TSG RAN Meeting #24 **RP-040251**
Seoul, Korea, 2 - 4 June 2004

Title **CRs (Rel-5 & Rel-6) to 25.101 & 25.133 for corrections to UE output power and TFC selection with HS-DPCCH**
Source **TSG RAN WG4**
Agenda Item **7.5.5**

⌘ **25.101** **CR** **341** ⌘ **rev** **1** ⌘ Current version: **5.10.0** ⌘

⌘ **25.101** **CR** **343** ⌘ **rev** **2** ⌘ Current version: **5.10.0** ⌘

Figure 6.5A: Transmit template during Ack/Nack transmission

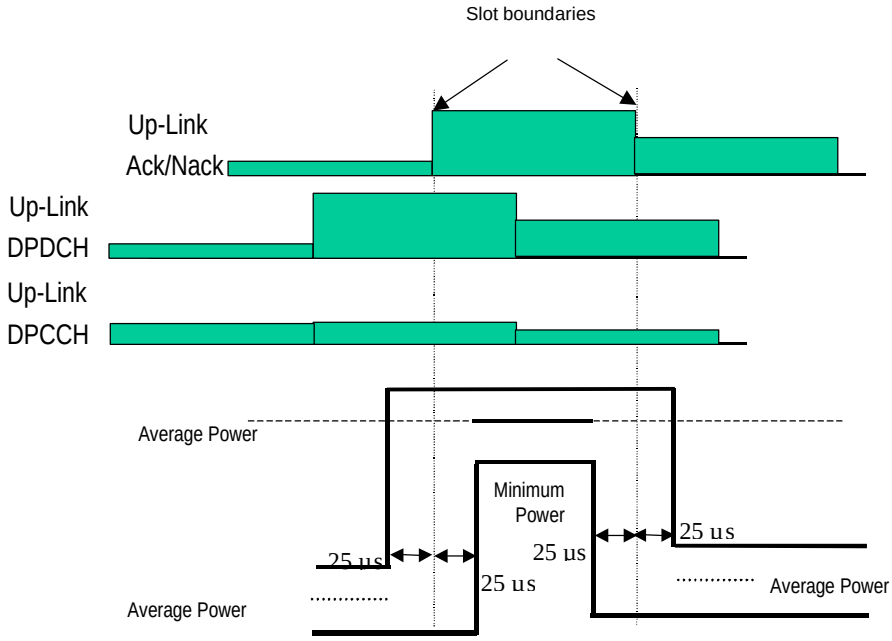
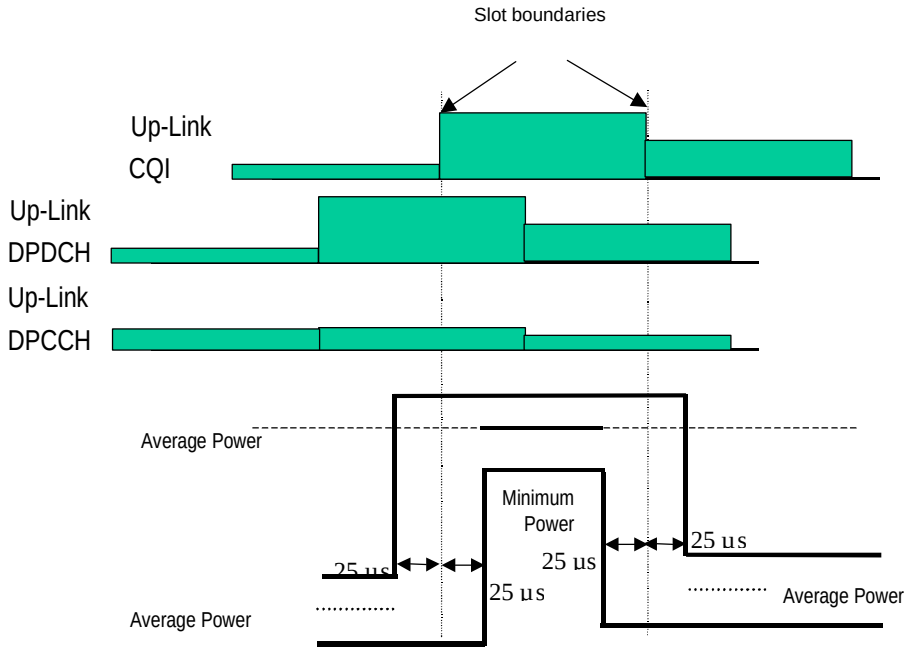
Power step size (Up or down) ΔP [dB]	Transmitter power step tolerance [dB]
0	+/- 0.5
1	+/- 0.5
2	+/- 1.0
3	+/- 1.5
4 ≤ Δ P ≤ ~~6~~7	+/- 2.0

The transmit power levels versus time shall meet the mask specified in Figure 6.x.

Figure 6.5A: Transmit template during Ack/Nack transmission

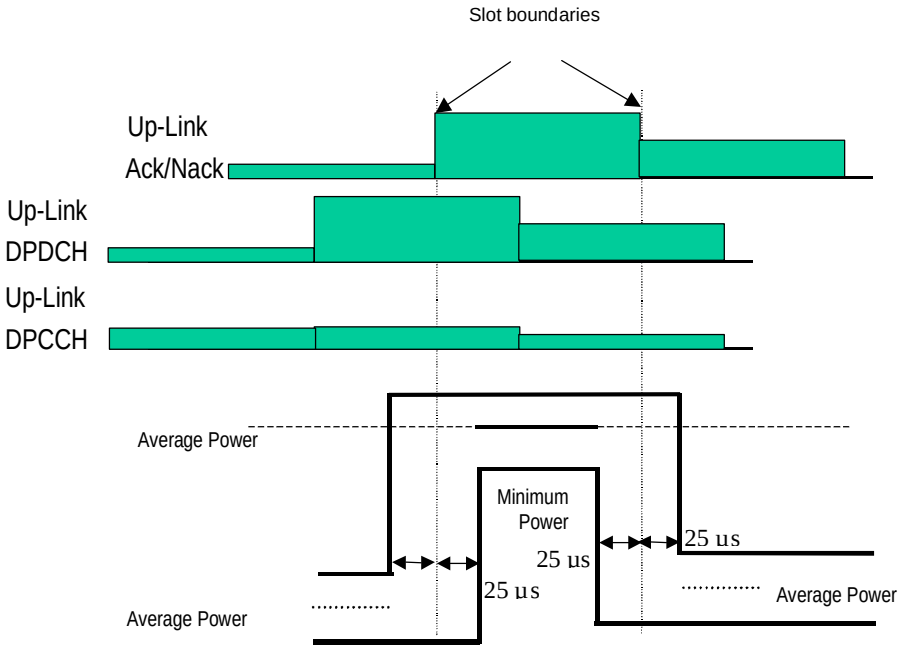
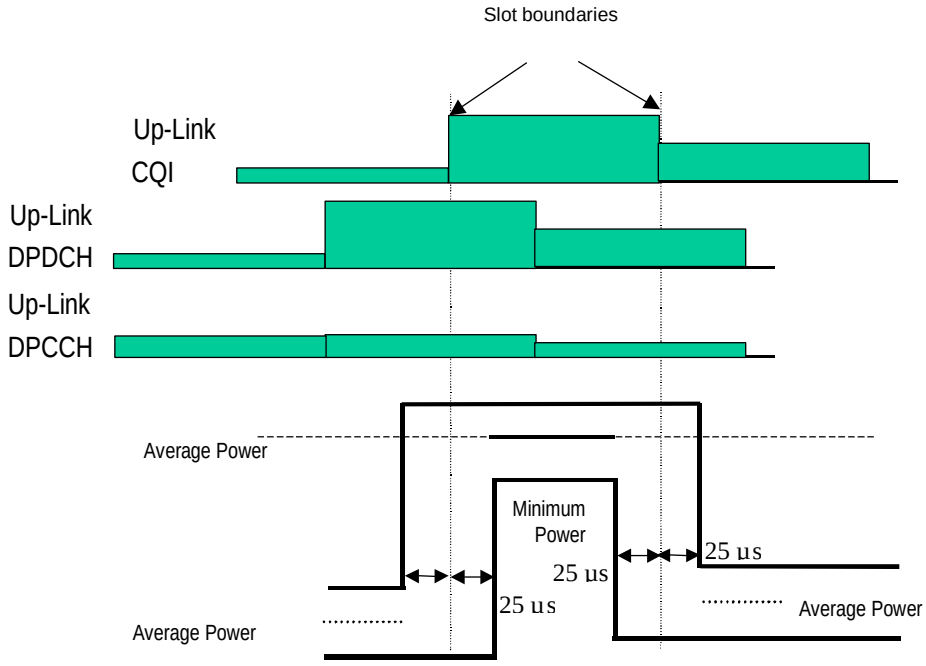
Power step size (Up or down) ΔP [dB]	Transmitter power step tolerance [dB]
0	+/- 0.5
1	+/- 0.5
2	+/- 1.0
3	+/- 1.5
4 ≤ Δ P ≤ ~~6~~7	+/- 2.0

The transmit power levels versus time shall meet the mask specified in Figure 6.x.
